# Access Compliance Report

### (Curb Ramps)

Intersection ID: 15247	Main Street: E_INDEPENDENCE_BV	Cross Street: EASTWAY_DR_RA	Location:	N
ADA ID: A4429173C2A5	Ramp Type: Perp	Initial Pass/Fail: Fail	Overall Compliance: No	Severity Score: 21.25
Codes/Mitigation Info/Possible Solution		Field Measurements/Component Compliance

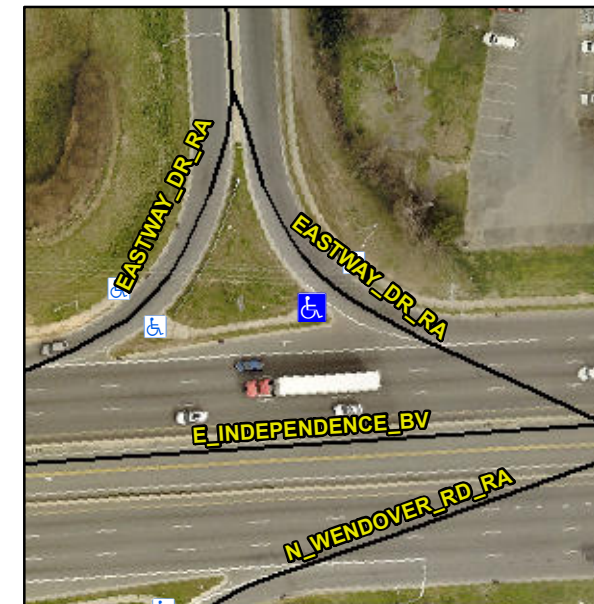
**Not Found, R304.5.1, R304.2.2**

Compliance	Description	Data	Compliance	Description	Data
N/A	Ramp Length (in)	54.0	No	Ramp Slope (%)	9.5
No	Ramp Width (in)	38.5	Yes	Ramp XSlope (%)	0.6
N/A	Flare Type LT	N/A	N/A	Flare Type RT	N/A
N/A	Flare Slope LT (%)	N/A	N/A	Flare Slope RT (%)	N/A
N/A	Flare Traversable LT?	N/A	N/A	Flare Traversable RT?	N/A
N/A	Landing Length (in)	N/A	N/A	DWS Provided?	N/A
N/A	Landing Width (in)	N/A	N/A	DWS Contrast?	N/A
N/A	Landing Slope (%)	N/A	N/A	DWS Length (in)	N/A
N/A	Landing X Slope (%)	N/A	N/A	DWS Full Width?	N/A
N/A	Landing Curb? (Y/N)	N/A	N/A	DWS Offset (in)	N/A
N/A	Shared Landing?	N/A			
N/A	Gutter Ponding?	N/A	N/A	Gutter Slope (%)	N/A
N/A	Gutter Lip Ht (in)	N/A	N/A	Gutter X Slope (%)	N/A
N/A	Painted X Walk1?	No	N/A	Painted X Walk2?	N/A
	X Walk 1 Direction	To NE		X Walk 2 Direction	N/A
N/A	X Walk 1 Width (in)	N/A	N/A	X Walk 2 Width (in)	N/A
	X Walk 1 Slope (%)	7.2		X Walk 2 Slope (%)	N/A
	X Walk 1 X Slope (%)	1.3		X Walk 2 X Slope (%)	N/A

**Remove & Replace Entire Ramp.**
